Project	IEEE 802.16 Broadband Wireless Access Working Group http://ieee802.org/16 >		
Title	Reallocation Scheme in Persistent Allocation		
Date Submitted	2008-03-13		
Source(s)	Sungkyung Kim, Sungcheol Chang, Kwangjae Lim, Chulsik Yoon, Seokheon Cho, Sunggeun Jin, Hyun Lee	Voice: +82-42-860-6448 E-mail: cyrano@etri.re.kr scchang@etri.re.kr kjlim@etri.re.kr csyoon@etri.re.kr

Reallocation Scheme in Persistent Allocation

Sungkyung Kim, Sungcheol chang, Kwangjae Lim, Chulsik Yoon, Seokheon cho, Sunggeun Jin, Hyun Lee, ETRI

Figure 1. De-allocation/allocation for the extension of MS-2's persistent resource

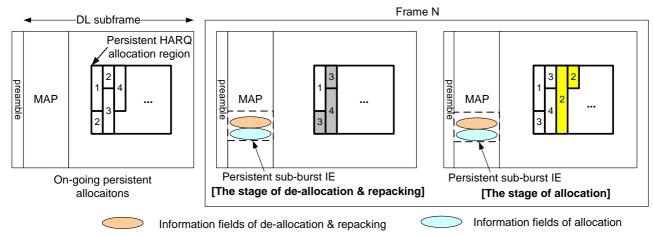
As one solution to AMC in persistent allocation scheme, we may consider that new persistent allocation will be made according to the updated MCS after the existing persistent resource is released. Figure 1 and Figure 2 show the examples of resource re-assignment in persistent allocation. As shown in Figure 1, in case that the MS-2 requires more slots because of poor channel condition, the MAP should include not only information fields of de-allocation/repacking but also information fields of allocation which appear in a persistent sub-burst IE.

Figure 2. De-allocation/allocation for the shrink of MS-2's persistent resource

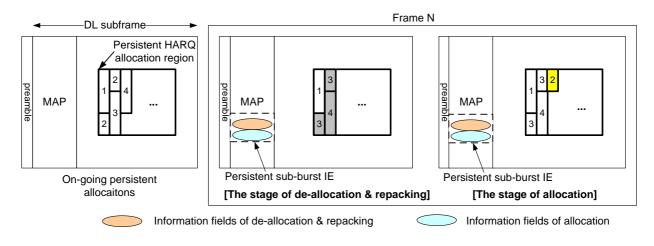
Figure 2 shows the case that some slots allocated to MS-2 is reduced in persistent allocation. Like the preceding example in Figure 1, the fields for both de-allocation/repacking and allocation are needed. These two separate repacking and re-allocation will generate some overheads which can be, however, minimized with careful consideration that both processes and closely coupled.

Figure 3. Reallocation for MS-2's persistent resource

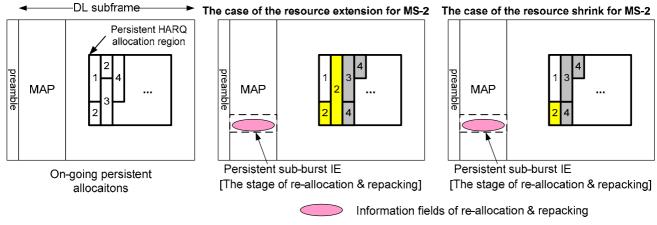
This contribution proposes a modified persistent sub-burst IE which can perform both reallocation and repacking using one bundle of information fields. Figure 3 shows the re-arrangement of persistent allocation using the proposed IE format.

The proposed IE formats are shown on the session of proposed text in detail. "Delta Duration" field in modified persistent sub-burst IE provides information about reallocation and repacking. In case that RCID of MS is equal to RCID value in the IE relative to the bundle of information fields, the corresponding MS should

update its own allocation information using "Delta Duration" field. Otherwise, this field should be also interpreted as repacking by other MSs.

Moreover, 1 MSB of "Delta Duration" field indicates the direction of resource rearrangement. When it is set to 1, the reallocated slots could be increased such as the case of the resource extension of MS-2 in Figure 3. Here, we note that slot offset for repacking should be the sum of the difference of duration (other LSBs of "Delta Duration" field) and its own slot offset, ensuring that the repacked and reallocated region do not cause some collisions with the involved MSs. Otherwise, in case that it is set to 0, reallocated slots could be decreased and the direction of repacking is equal the same as the direction of repacking in de-allocation case.

Figure 4. Persistent Chang Counter in UL sub-frame.

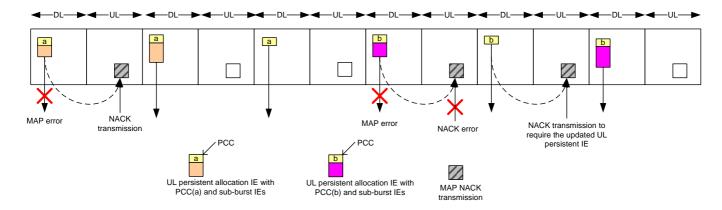
According to MAP error detection scheme using MAP NACK channel, a MS will transmit a MAP NACK signal through the Fast Feedback channel region when that it does not successfully receive the MAP in a Persistent allocation frame. However, there can be some ambiguity in persistent allocation in case that the BS fails to receive the MAP NACK signal at frame N and the MS which transmitted MAP NACK signal relevant to the frame N successfully receive the MAP at frame N+Allocation Period. When the MS decodes the MAP without any change in UL persistent allocation at frame N+Allocation Period, the MS resumes its own persistent allocation. However, MS's burst transmission on the UL persistent allocation can cause a sequential collision with other transmission if the MAP at frame N included some changes. Hence, we focus on the case of UL persistent allocation by reason of possibility that sequential collisions may occur in such a circumstance.

We consider an approach of change counter in order to keep away from the collision problem caused by MAP NACK channel errors. As shown in Figure 4, a BS increases a PCC (Persistent Change Counter) relevant to the persistent allocation group as resource allocation arrangement is changed. It is noted that the PCC value can be increased by one in an allocation period even though the allocation IE includes many reallocations and/or rearrangements. A MS involved in uplink persistent allocation group should store its PCC value and update it when the change of persistent allocation occurs. When decoding the MAP in the next period after MAP error detection, if MS's own PCC value is not equal to the PCC in persistent allocation IE transmitted from the BS, the MS should transmit a NACK in the shared MAP NACK channel in order to request for a retransmission of the updated persistent allocation IE. The MS shall not transmit any persistently allocated burst until it successfully receives the updated persistent allocation IE.
